PLANT NAME: Nine Mile Point # 1

ENCLOSURES:
Safety evaluation for modification of providing add'l Spent Fuel Storage Capacity.....

Re: Nine Mile Point Unit 1
Docket No. 50-220

SAFETY EVALUATION FOR ADDITIONAL SPENT FUEL STORAGE CAPACITY

SPENT FUEL POOL
WITH PROPOSED ADDITION

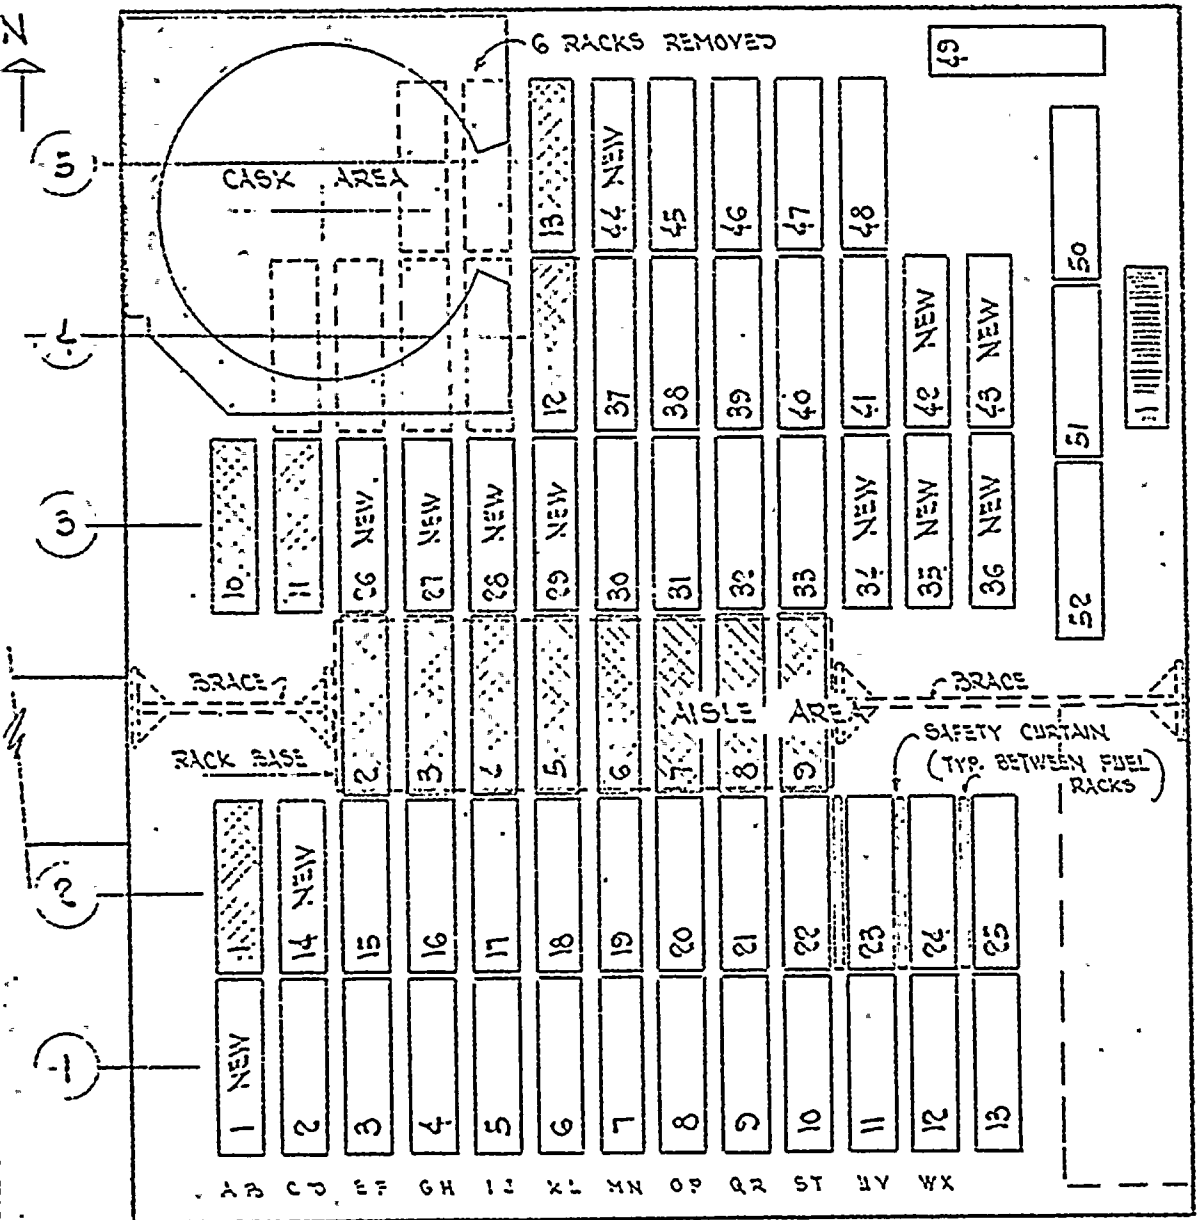
Twelve additional spent fuel storage racks, with the capacity for 240 bundles are proposed. They are identified as "New" in the attached illustration, and will be identical in design to the original racks. Also, spacing of the racks will be identical to the original design.

The addition of the spent fuel storage racks will require that eight control rod racks be moved from their swing bolt positions to an aisle area of the pool floor, per the attached illustration. There, they will be bolted to a support base, and braced laterally for seismic considerations.
